## City Plan 9.3.8 Extractive Industry Zone non-compliance - Southwest corner

Here is the most recent submitted 'Stage 1' proposal (February 18<sup>th</sup> 2021):

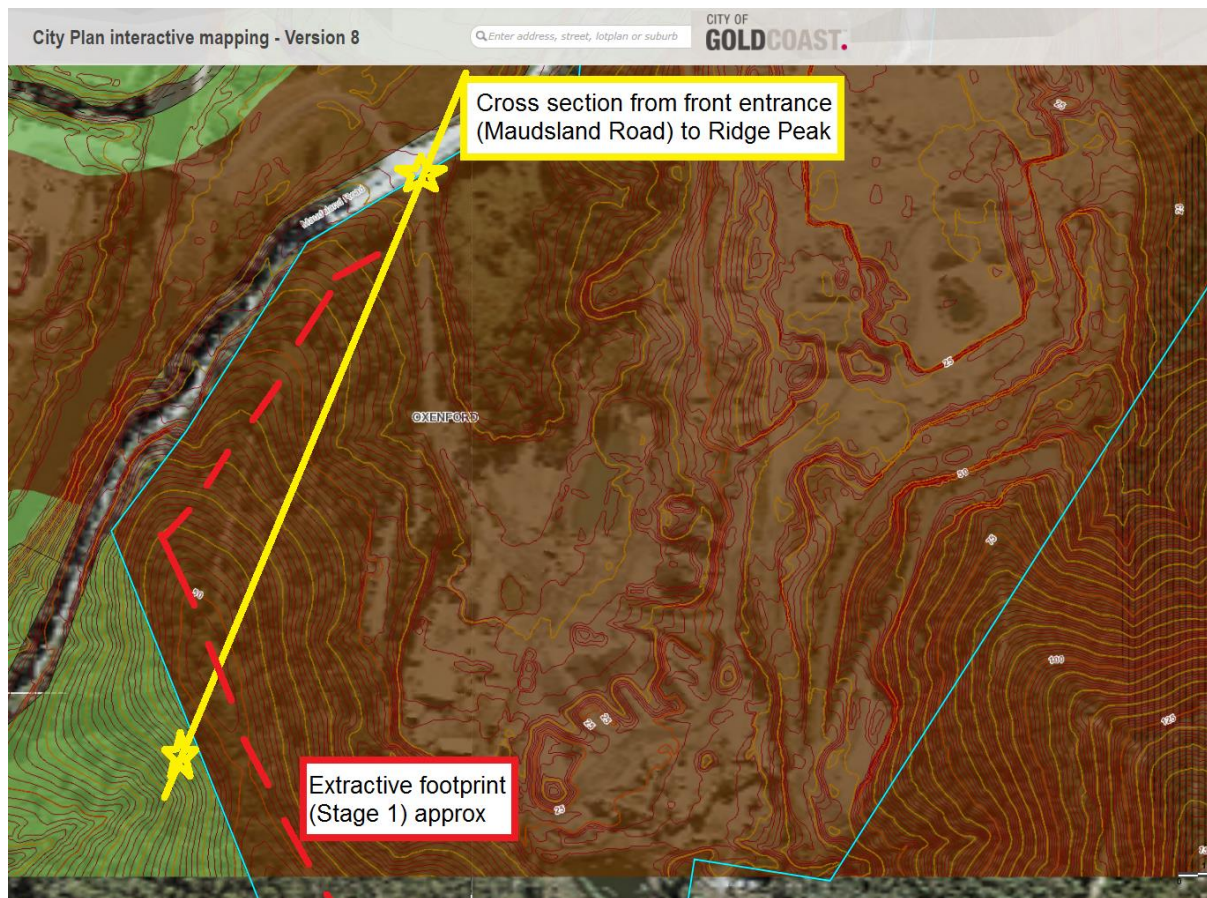
It is abundantly clear to see that from Stage 1 onwards it would seem the quarry fails to meet the requirements of Extractive Industry development code, 9.3.8, Visual Amenity, Performance Outcome PO3: *“Extractive Industry developments are screened or located in areas of least visual impact and minimise views of any significant infrastructure and visually obtrusive development from major roads and surrounding residential areas”*. Clearly, views from Maudsland Road will be visually obtrusive.

It also fails acceptable Outcome AO3.2: *“Views of significant infrastructure and visually obtrusive development including quarry floors, benches and faces, are screened from the road frontage, major road corridors and adjoining residential areas”* as clearly it will be highly visible from the Maudsland Road from Stage 1 onwards.

Based on this, we believe the current cross section is:

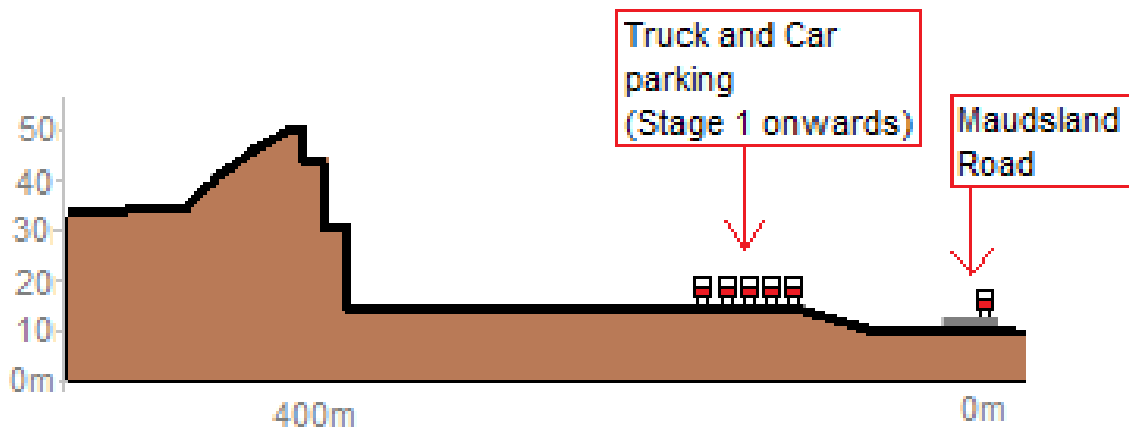
It also fails Performance Outcome PO4: *“Development protects the visual character and amenity of the area by ensuring ridgelines are retained as a natural feature and buffer”* with an Acceptable Outcome AO4 of: *“Development is located at least 40m away from any ridgeline, as measured horizontally from the ridge peak”*. As the proposed ‘**Stage 1**’ benching consumes a considerable proportion of the 50 metre high ridge peak which is clearly NOT *“at least 40m Away from any ... ridge peak”* as is required under the City Plan.

**Figure 40: Annotated aerial image of ridgelines (Source: Google Earth / Insight DAS)**

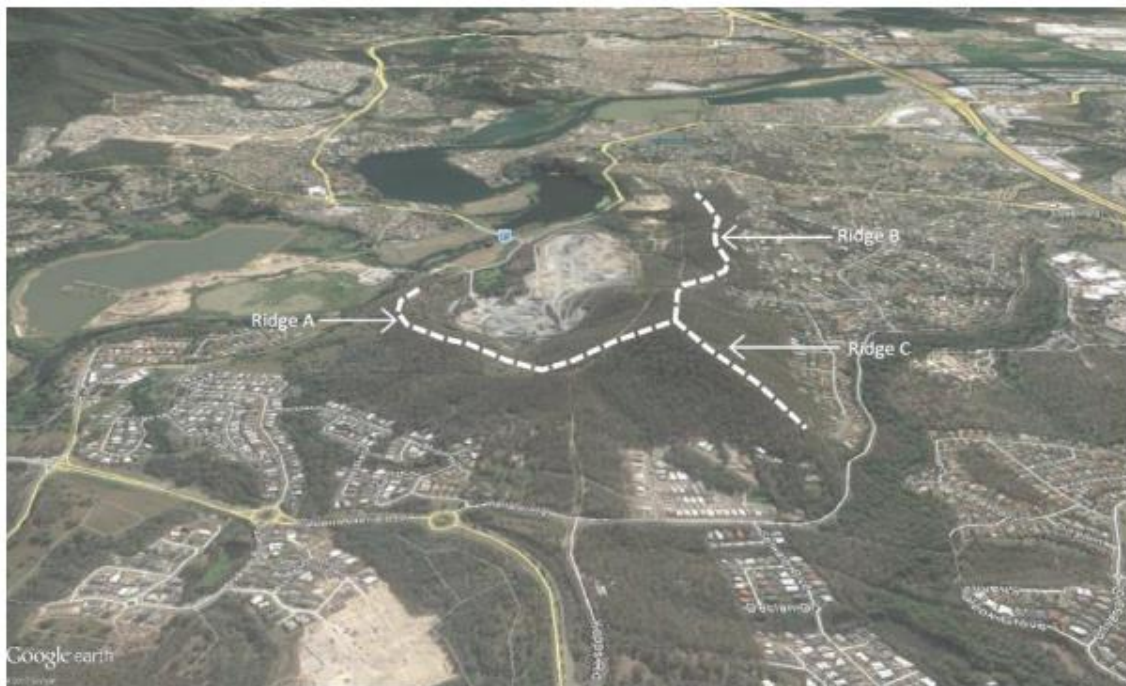
Unfortunately, it would seem, the City Officer's report fails to identify that the '*Stage 1*' extractive footprint encroaches onto this ridge peak and will be highly visible from the Maudsland Road and surrounding areas.

We do not believe Council Officers have applied due diligence to establish the views in this area from '*Stage 1*' onwards.

It should also be realised that ‘Stage 1’ extractive footprint, in this southwest corner, is also encroaching on prohibited development areas as identified in Council Officers Report ‘Figure 6 - Gold Coast City Plan’ (areas highlighted for clarity):

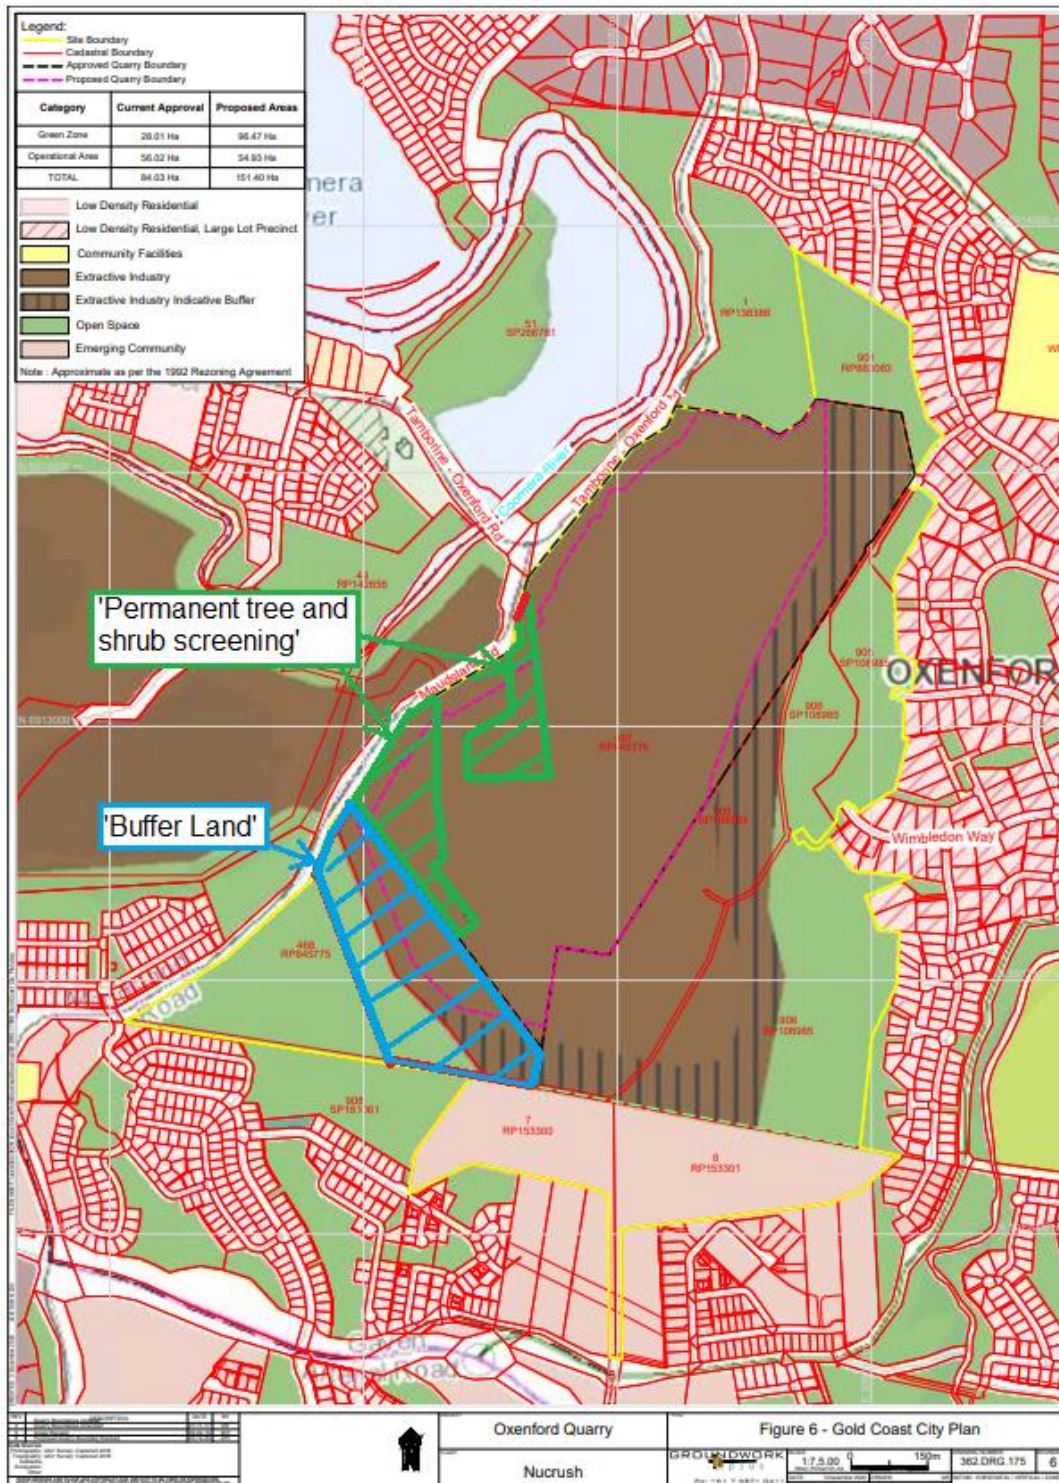
It is clear that 'Stage 1' onwards the applicant is proposing quarrying these areas despite their protected status under current approval.

Ignoring this separation buffers will, we believe, result in clear views of the quarry operations (including benching, quarry faces and truck and car parking areas) from the Maudsland Road and surrounding areas.

It would seem the *'Buffer Land'* and *'Permanent Tree and shrub screening'* areas were well considered at the time of the quarry's inception and ignoring these areas would seem a grave mistake by Council Officer's.
